Site Accessibility Evaluation

CSPD Impound Lot

Accessibility Evaluation

SUBJECT: CSPD/Impound Lot Self-Evaluation

Finding 182901 Main Photo

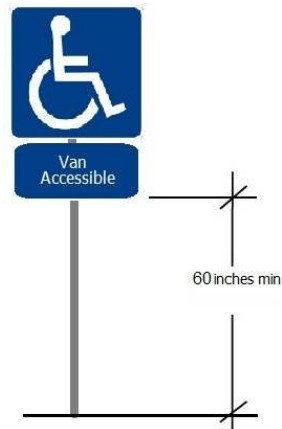
Finding: 1

The parking sign is mounted too low.

The three signs are mounted at 58" to the bottom edge (none are van accessible).

Raise existing signs so they are 60 inches minimum above the ground surface.

Add van access sign to the far left parking space closest to the door.

Finding 182902 Main Photo

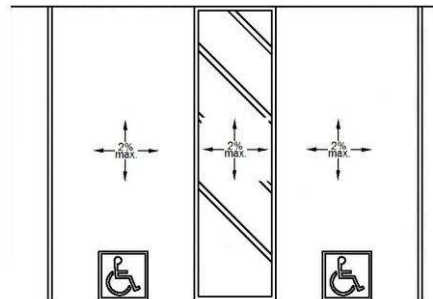
Finding: 2

The cross slopes (narrow dimension) and/or running slopes (long dimension) of the accessible stall exceeds 2%.

40' long x 4' wide across the parking spaces and access aisles running slopes as high as 3%.

Correct the cross slope of the stalls to 2% or less.

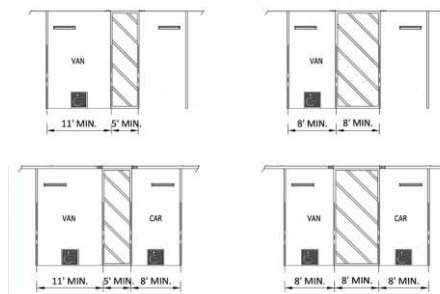
Finding: 3

The accessible parking stall is not wide enough.

Accessible parking space on the right is 7'6"

Re-stripe parking space.

Finding 182926 Main Photo

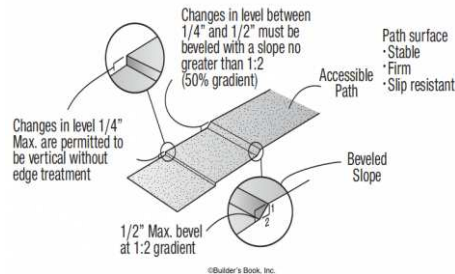
Finding: 4

The accessible route contains loose gravel and/or surfaces that do not provide for a stable, firm slip resistant surface.

Pick-up area surface
not firm, stable, or
slip resistant.

Pave concrete pad adjacent to walkway to allow ample space for pick-up.

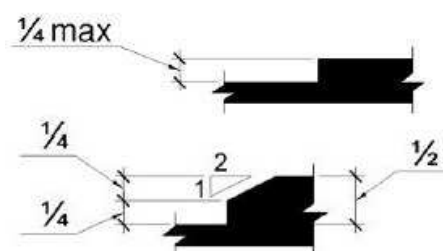
Finding: 5

The walkway contains abrupt vertical edges and/or variations over a 1/4 inch.

There are areas of vertical displacement up to 2" where the concrete meets the loose fill

Connect the sidewalk to the future concrete pad where customers will pick up vehicles

Finding 182927 Main Photo

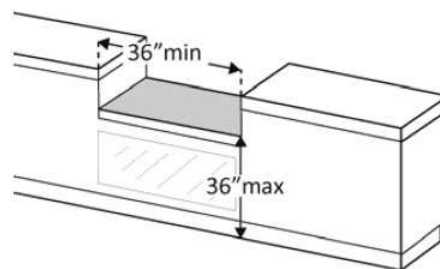
Finding: 6

The transaction counter is too high.

Customer service access 42" above floor grade.

Lower security window 6-8". The reach range is OK and the line of sight is marginally alright.

Until counter is corrected, staff must be ready, willing, and able to provide service at an alternate, accessible location.

Finding 182929 Main Photo

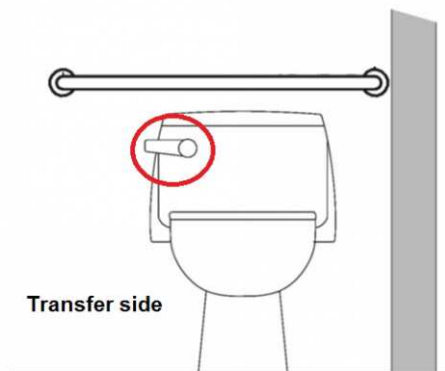
Finding: 8

The flush handle is located on the wrong side of the toilet.

Flush is on the closed side.

Move the flush to open side (this will require obtaining another tank).

Finding 182930 Main Photo

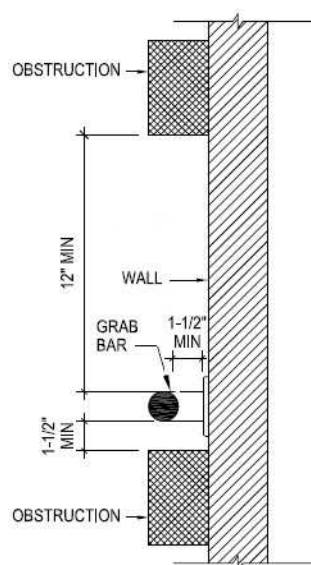
Finding: 9

The grab bar is not spaced correctly to the wall or other elements.

Toilet seat covers are only 3.5" above the bar.

Move the toilet seat covers to 1.5" below the grab bar.

Finding 182931 Main Photo

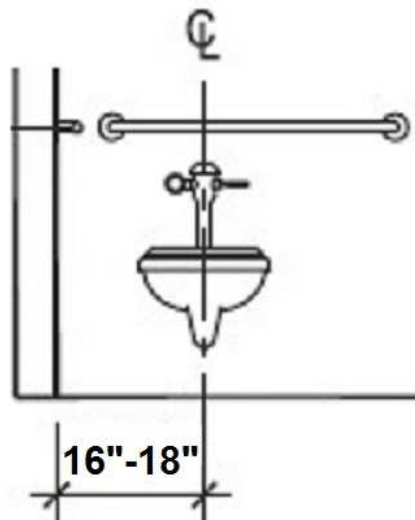
Finding: 10

The toilet is not located within the range allowed from the side wall or partition.

The toilet is 1/2" too far from the wall at 18.5" to the centerline of the toilet.

Move toilet over 1/2"+, (use flange) if feasible. If not the wall can be moved over the same distance

Finding 182932 Main Photo

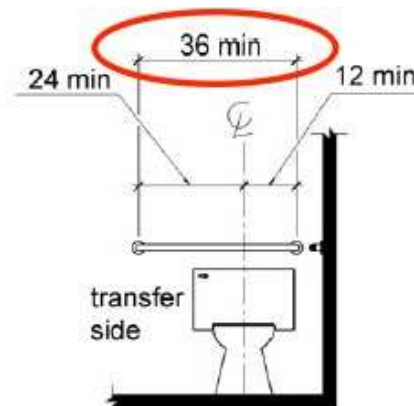
Finding: 11

The rear grab bar is not a minimum 36 inches in length.

Rear grab bar 30" long.

Remove existing rear grab bar and replace with 36" grab bar.
